## CALIFORNIA COASTAL COMMISSION

STAFF REPORT: PERMIT AMENDMENT

APPLICATION NO.: 5-88-918-A2

DESCRIPTION OF AMENDMENT: Restoration of unpermitted grading of bluff to return path to original contour; construct 60 linear feet of retaining wall with a maximum height of five feet along seaward side of path at top of bluff; restore contour of bluff at site of erosion with 15 cubic yards of fill; restore vegetation on bluff with native plants; place railroad ties along entire length of path on both sides for erosion control; changes to the height of the retaining wall at the base of the bluff by tapering each end to the 30 foot contour and reducing the height by up to five feet, raising the height of the center of the wall by one foot to a maximum height of eleven feet, reducing the length of the retaining wall by three feet to a total length of 79 feet, modifying the shape of the wall to eliminate cutting into the bluff, and backfilling of the slope with 40 cubic yards of fill; placement of irrigation below grade on bluff to be used for a one year period.

Exhibit 4: Proposed Site Plan  
5-88-918-A2

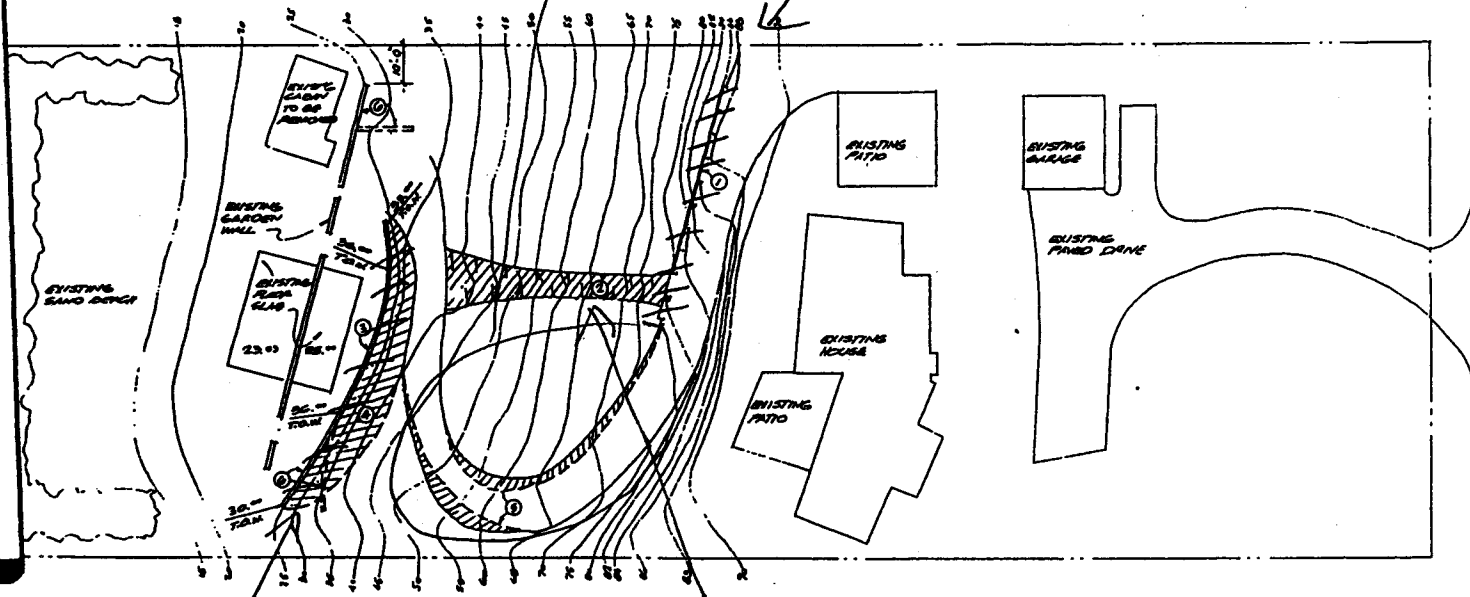
- ① 60 LBL. FT. OF SHIELD CONSISTS OF 12" STEEL PILES SET IN CONCRETE 66" O. D. C. 4" BY 1000 LIGGING - TO REMAIN.
- ② EROSION DUE TO RECENT STORM DAMAGE - TO BE TRAINED AND BACKFILLED TO ORIGINAL GRADES.
- ③ NEW RETAINING WALL CONSTRUCTED PER PERMIT DRAWING EXCEPT AS NOTED.
- ④ SLOPE CUT FOR CONSTRUCTION OF RETAINING WALL TO BE BACKFILLED UPON COMPLETION OF WALL.
- ⑤ EXISTING PATH WIDENED FOR CONSTRUCTION ACCESS - TO BE RESTORED TO ORIGINAL WIDTH.
- ⑥ CONFIGURATION OF WALL END REVISED TO REDUCE INTRUSIVE CUTS IN SLOPE - TO REMAIN AS-BUILT.

APPROVED WALL  
AT BASE OF BLUFF

RESTORATIVE GRADING  
TO FIX BROOD AREA  
(WASHOUT)

**Exhibit 6: Revegetation Plan**  
5-88-918-A2

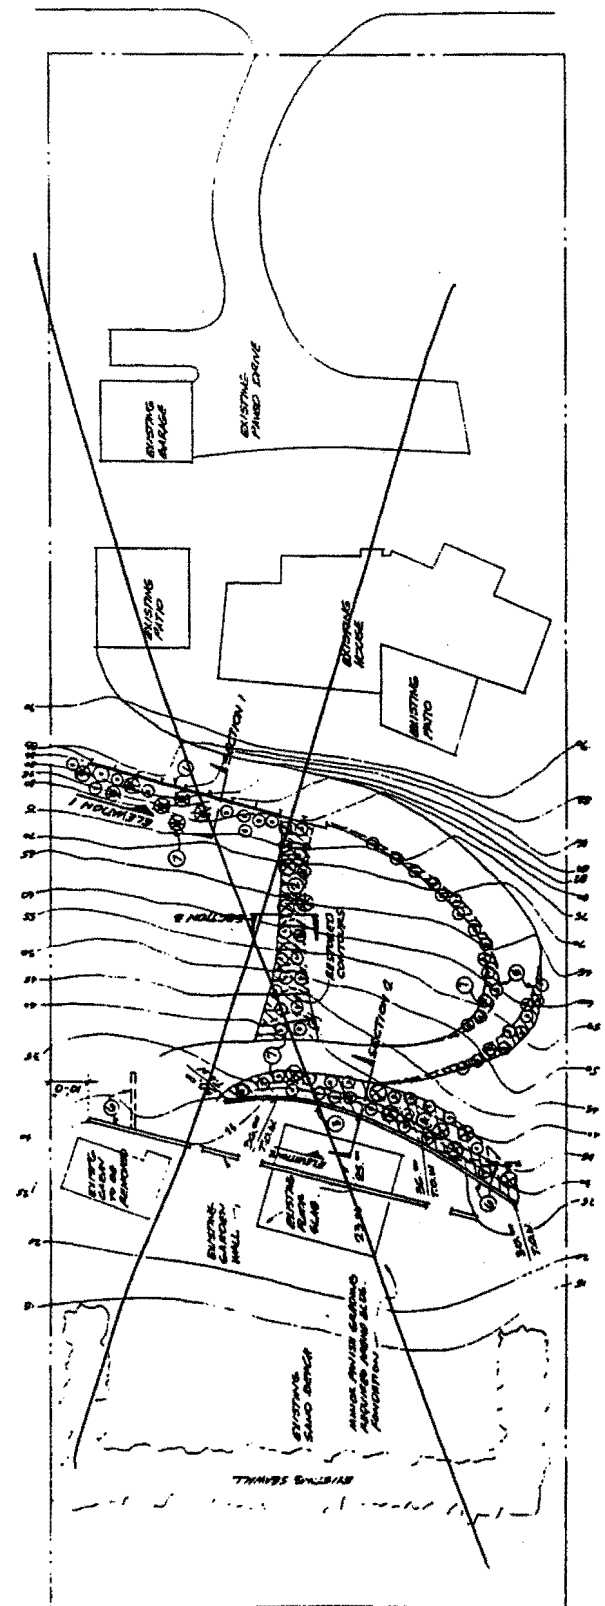
EMERGENCY EROSION CONTROL OVERHEAD IRRIGATION SYSTEM TO BE INSTALLED PRIOR TO PLANTING AND SEEDING. SYSTEM TO BE MAINTAINED UNTIL SLOPE PLANTING IS ESTABLISHED (APPROXIMATELY TWO YEARS). IRRIGATION VALVES MUST BE OPERATED MANUALLY ONLY AND MUST BE TURNED OFF AS SOON AS VISIBLE IRRIGATION RUN-OFF APPEARS ON THE SLOPES. FROM NOVEMBER THROUGH APRIL, THE SYSTEM SHOULD BE USED ONLY TO PROVIDE IRRIGATION WATER TO THE PLANTS WHEN TWO WEEKS HAS PASSED SINCE 1/2" OR MORE OF RAINFALL HAS OCCURRED. FROM MAY THROUGH OCTOBER, THE IRRIGATION SYSTEM MAY BE USED A MAXIMUM OF ONCE A WEEK.

The applicant agrees to complete the implementation of the restoration plan including the removal of exotic, invasive species from the bluff face within one year of the issuance of the permit, but no later than April 1, 1998.

**Exhibit 7: Irrigation Notes  
5-88-918-A2 on Revegetation Plan**

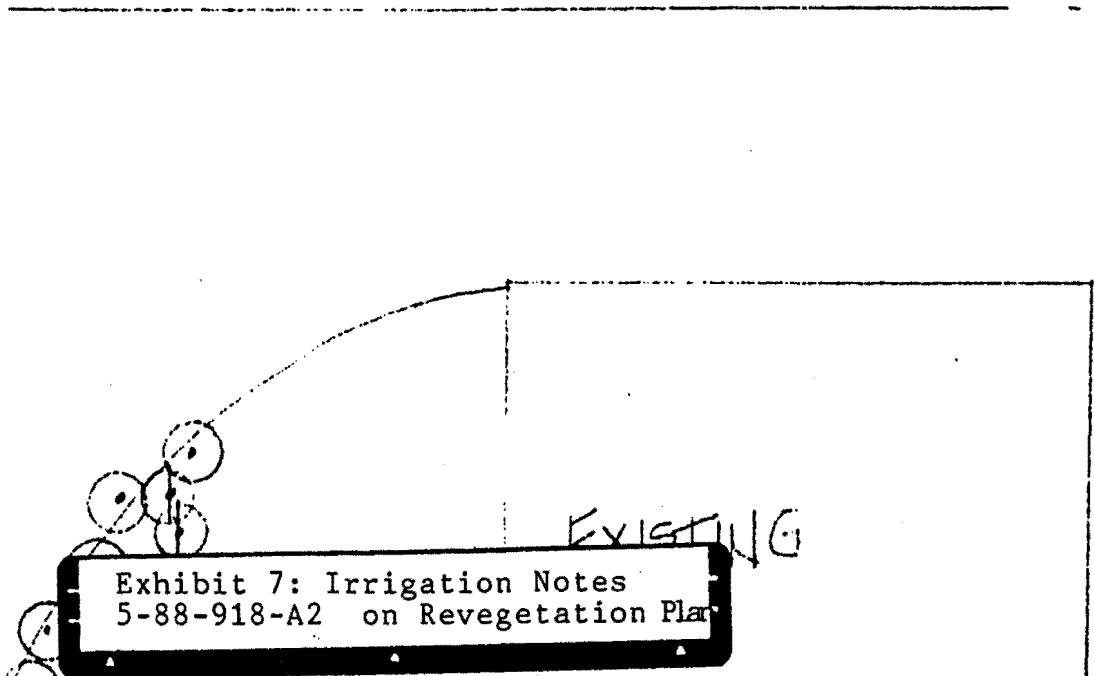
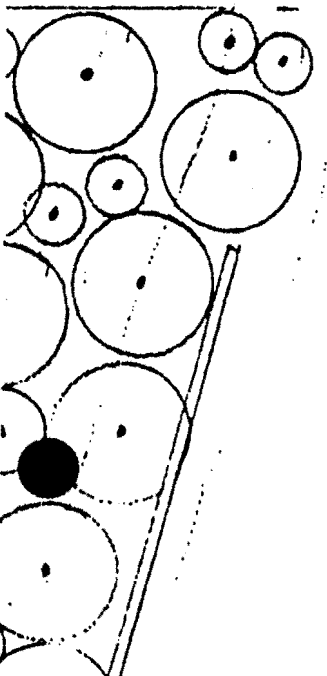
The length of time for the irrigation to be used has been changed from two years to one year. The watering of young plants for a period of two years is too long and increases the plants chances of becoming water reliant. Young plants do not need additional water for more than one season. By the second season, plants should be able to survive the normal conditions of the area. Thus these plants should not need additional watering in the second year. If they do receive additional water there is a greater chance of reducing their long term survivability rates. The applicant has agreed to dismantle the irrigation system on the bluff after one year as noted in special condition 4.

**EMERGENCY EROSION CONTROL OVERHEAD IRRIGATION SYSTEM TO BE INSTALLED PRIOR TO PLANTING AND SEEDING. SYSTEM TO BE MAINTAINED UNTIL SLOPE PLANTING IS ESTABLISHED (APPROXIMATELY TWO YEARS). IRRIGATION VALVES MUST BE OPERATED MANUALLY ONLY AND MUST BE TURNED OFF AS SOON AS VISIBLE IRRIGATION RUN-OFF APPEARS ON THE SLOPES. FROM NOVEMBER THROUGH APRIL, THE SYSTEM SHOULD BE USED ONLY TO PROVIDE IRRIGATION WATER TO THE PLANTS WHEN TWO WEEKS HAS PASSED SINCE 1/2" OR MORE OF RAINFALL HAS OCCURRED. FROM MAY THROUGH OCTOBER, THE IRRIGATION SYSTEM MAY BE USED A MAXIMUM OF ONCE A WEEK.**

The applicant agrees to comply with and implement all of the irrigation notes and instructions listed on the revegetation plan with regards to the watering of the site. Watering shall occur no more than once a week and only during periods of no rainfall.

The irrigation system may only be used for one-year commencing with the implementation of the revegetation. No more than one year from the date of the approval of this permit amendment, all above grade portions of the system including the risers and heads shall be removed and the main line at the top of the bluff shall be capped. The irrigation period may be extended by the Executive Director, for good cause, pursuant to a recommendation by the consulting restoration specialist that additional watering is necessary for the long-term survival of the vegetation on the bluff face.

No long-term irrigation of the bluff face is permitted.
